Name: Guardian Storage - SPR - 2260 I-70 Business Loop

Re: Modifications, Hydrologic Analysis, Guardian Storage
Facility, 2260 E. Main Street, Grand Junction, Colorado

REVIEW COMMENTS

TITLE HEADING: Site Plan Review
Mini-Storage Units

SITE DRAINAGE PLAN
11/23/93

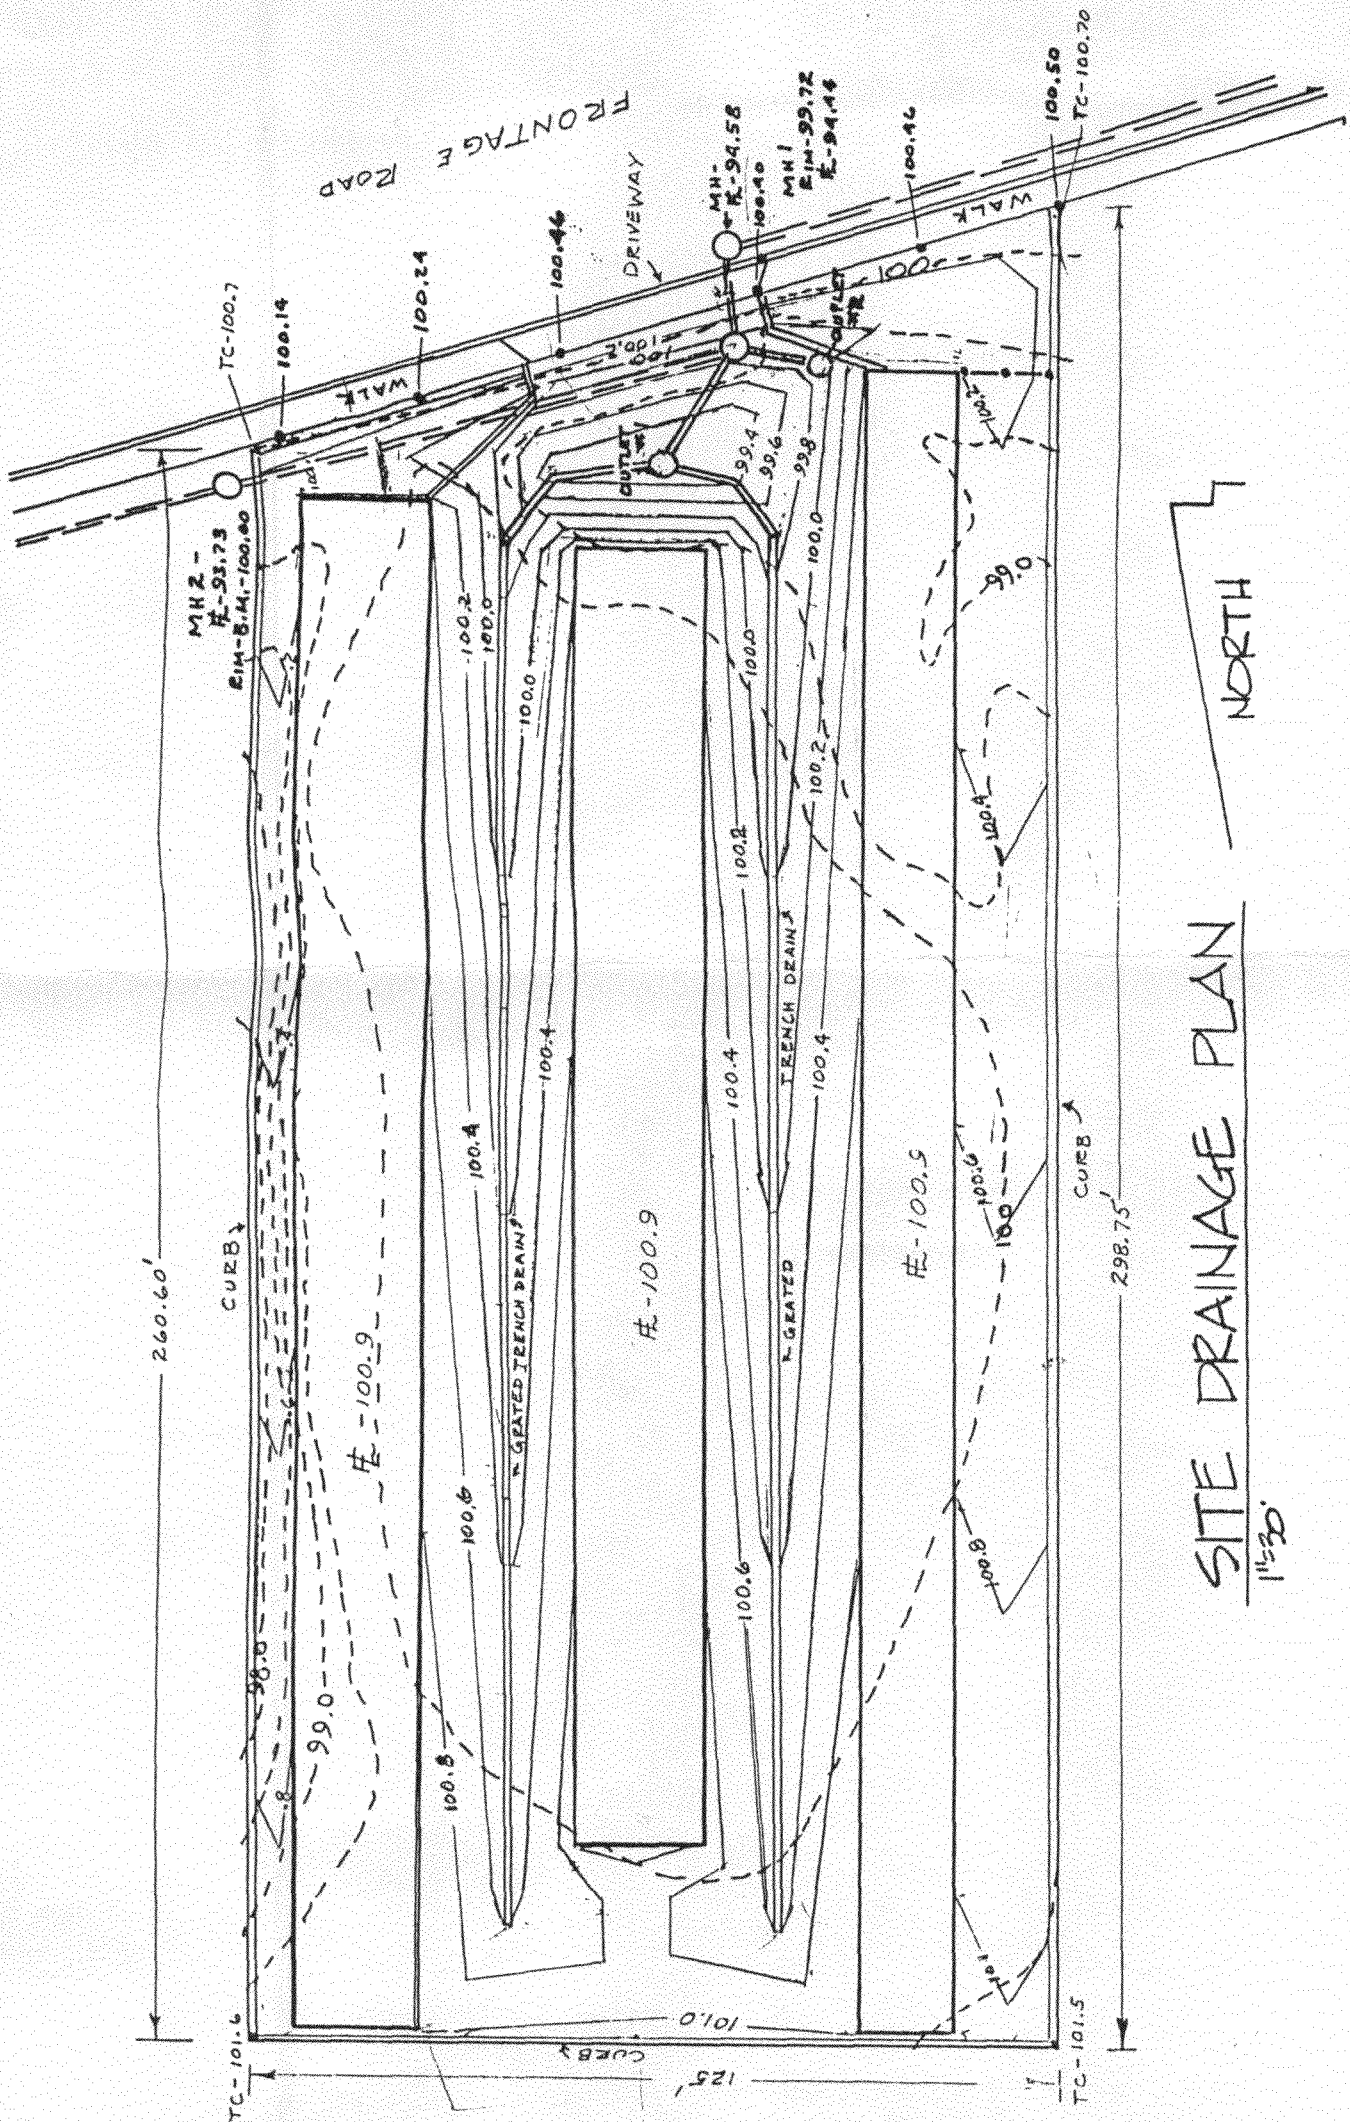
1. Provide curbing to contain/direct runoff as shown on the Drainage Plan. Also, curbing or berming is required between the driveway and the SE corner of the property to a minimum elevation of 100.4.
2. Replace broken monolithic curb/gutter/sidewalk.

1. Information provided in the Drainage Report was not transferred to the plans as it must be. Also provide orifice sizes, once corrected by Lincoln-DeVore.
2. Add berming or curbing along the sidewalk.

Revised ponding elevation and orifice sizes must be resubmitted as discussed with George Morris

1. We are currently bringing together cost estimates to provide curbing on the east and west property boundaries which would contain all site water to a minimum elevation of 100.4. An alternative plan to change the roof slope of Buildings A and C to drain toward the center of the project and alleviate drain water from being discharged into the east and west landscape areas is seriously being considered at this point, however. Either the curbing/berming at the perimeter or a roof pitch change to the interior will be acceptable to the owner. The owner, however, would like to reserve the right to make the final decision. A berm shall be installed in the landscape area on the south east corner of the lot along the sidewalk and returning to the building to a minimum elevation of 100.4 to detain water in the center basin.

1. Additional information has been transferred to the plans per review comments.
2. Berming has been added along the sidewalk and southeast corner as described above.

As of the time of this transmittal the revised drainage report with orifice sizes have not been received by Kelco from Lincoln Devore. We will forward this revised drainage report under separate cover to you promptly upon it's receipt.

4-20-93
 Guardian Storage
 2660 E Main
 Kelly Ford
 Δ 5-11-93

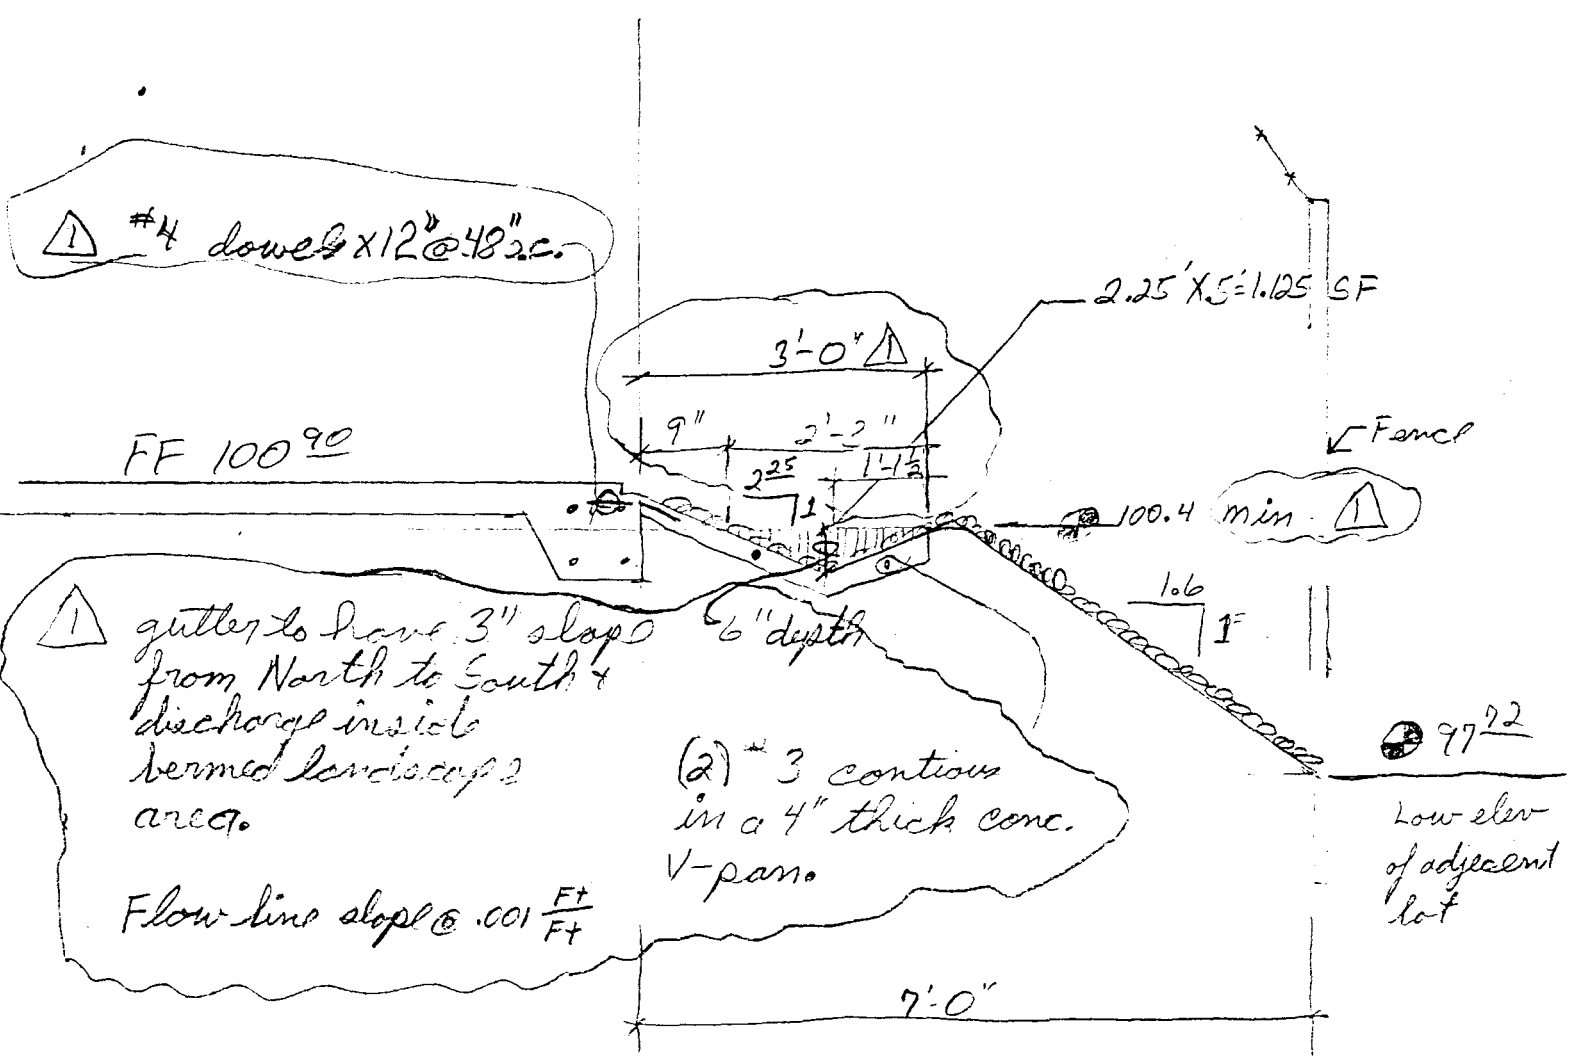
As requested, the sketch showing a triangular ditch along the easterly side of the above referenced property has been reviewed. We understand that you intend to place a triangular ditch along this property line, formed by a filled slope along the east side of the property, eventually intersected by the slope along the building. We further understand that you will riprap the side slope extending downward to the adjoining property for erosion protection. In addition, we understand that you intend to pave the resulting triangular ditch with asphalt, or possibly concrete, pavement as shown on the sketch you sent to me.

We are not sufficiently familiar with Grand Junction regulations concerning slopes onto adjacent property, so will not comment on this condition. From the standpoint of ditch and gradient, the triangular ditch will carry the runoff anticipated in this area insofar as quantity is concerned. The time of flow to the storm sewer at the front of the building is such that the timing and storage for the site previously calculated will not change sufficiently to change the previously submitted calculations. We understand that you have planned to change the roof slope along this building. Our analysis assumes that the roof change has been made, and that the triangular ditch is to be paved.

In our opinion, the change shown can be used on this site without changing the calculated drainage and flow conditions on the property.
